Access Compliance Report

Public Rights-of-Way

Intersection ID: 3852	Main Street: DERBY_MEADOWS_CT	Cross Street: WOODCOCK_LN	Location: SE
ADA ID: B8363E310D0E	Ramp Type: Perp	Initial Pass/Fail: Fail	Overall Compliance: No
Severity Score: 13.75			
Codes/Mitigation Info/Possible Solution		Field Measurements/Component Compliance

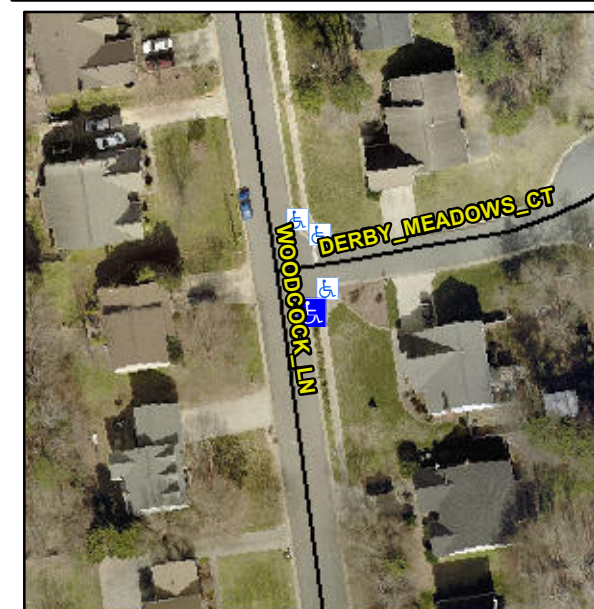
Not Found, R304.2.2, R304.5.3

Compliance	Description	Data	Compliance	Description	Data
N/A	Ramp Length (in)	48.0	No	Ramp Slope (%)	8.4
Yes	Ramp Width (in)	48.0	No	Ramp XSlope (%)	2.8
N/A	Flare Type LT	N/A	N/A	Flare Type RT	N/A
N/A	Flare Slope LT (%)	N/A	N/A	Flare Slope RT (%)	N/A
N/A	Flare Traversable LT?	N/A	N/A	Flare Traversable RT?	N/A
N/A	Landing Length (in)	N/A	N/A	DWS Provided?	N/A
N/A	Landing Width (in)	N/A	N/A	DWS Contrast?	N/A
N/A	Landing Slope (%)	N/A	N/A	DWS Length (in)	N/A
N/A	Landing X Slope (%)	N/A	N/A	DWS Full Width?	N/A
N/A	Landing Curb? (Y/N)	N/A	N/A	DWS Offset (in)	N/A
N/A	Shared Landing?	N/A			
N/A	Gutter Ponding?	N/A	N/A	Gutter Slope (%)	N/A
N/A	Gutter Lip Ht (in)	2.0	N/A	Gutter X Slope (%)	N/A
N/A	Painted X Walk1?	No	N/A	Painted X Walk2?	N/A
	X Walk 1 Direction	To W		X Walk 2 Direction	N/A
N/A	X Walk 1 Width (in)	N/A	N/A	X Walk 2 Width (in)	N/A
	X Walk 1 Slope (%)	1.7		X Walk 2 Slope (%)	N/A
	X Walk 1 X Slope (%)	1.6		X Walk 2 X Slope (%)	N/A

Remove & Replace Entire Ramp.
